**Written Statement**  
**Matter 6 - Better Homes Enfield**

**Policy PL5 – Meridian Water and Allocations SA5.1 – SA5.8**

SA1.1 (Phase 1).

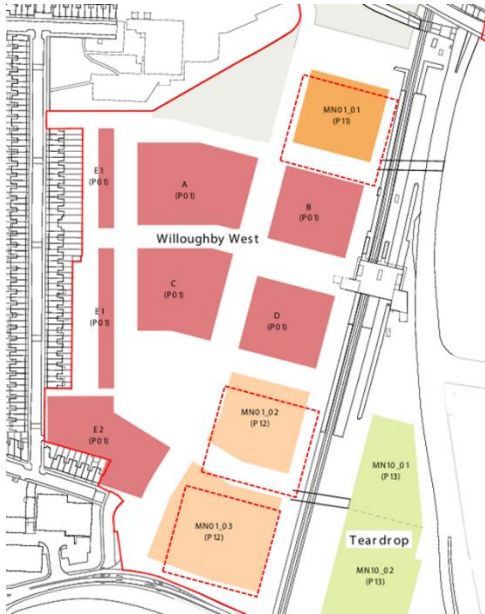
35. The quantum of “Approximate Estimated Non-residential capacity (Class E)” is missing.
36. SA1.1 has not accounted for Parcels 11 and 12 (see figure below – red dotted lines show missing parcels).
